Access Compliance Report

Public Rights-of-Way

Intersection ID: N/A	Main Street: SOUTHGROVE_ST	Cross Street: WAVERLY_WALK_AV	Location: NE
ADA ID: 20F8D79EA161	Ramp Type: Perp	Initial Pass/Fail: Fail	Overall Compliance: No
		Severity Score: 1.25

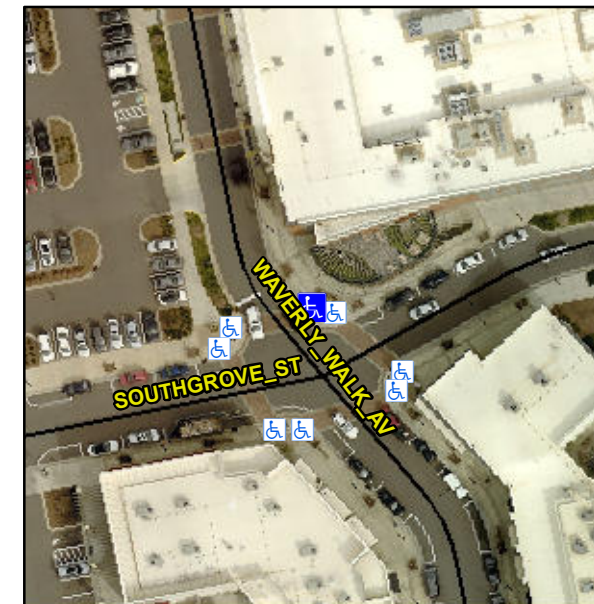
Not Found, R304.5.3

Compliance	Description	Data	Compliance	Description	Data
N/A	Ramp Length (in)	72.0	Yes	Ramp Slope (%)	7.4
Yes	Ramp Width (in)	48.0	No	Ramp XSlope (%)	2.4
N/A	Flare Type LT	N/A	N/A	Flare Type RT	N/A
N/A	Flare Slope LT (%)	N/A	N/A	Flare Slope RT (%)	N/A
N/A	Flare Traversable LT?	N/A	N/A	Flare Traversable RT?	N/A
N/A	Landing Length (in)	N/A	N/A	DWS Provided?	N/A
N/A	Landing Width (in)	N/A	N/A	DWS Contrast?	N/A
N/A	Landing Slope (%)	N/A	N/A	DWS Length (in)	N/A
N/A	Landing X Slope (%)	N/A	N/A	DWS Full Width?	N/A
N/A	Landing Curb? (Y/N)	N/A	N/A	DWS Offset (in)	N/A
N/A	Shared Landing?	N/A			
N/A	Gutter Ponding?	N/A	N/A	Gutter Slope (%)	N/A
N/A	Gutter Lip Ht (in)	N/A	N/A	Gutter X Slope (%)	N/A
N/A	Painted X Walk1?	Yes	N/A	Painted X Walk2?	N/A
	X Walk 1 Direction	To W		X Walk 2 Direction	N/A
N/A	X Walk 1 Width (in)	103.0	N/A	X Walk 2 Width (in)	N/A
	X Walk 1 Slope (%)	0.6		X Walk 2 Slope (%)	N/A
	X Walk 1 X Slope (%)	1.3		X Walk 2 X Slope (%)	N/A

Remove & Replace Entire Ramp.
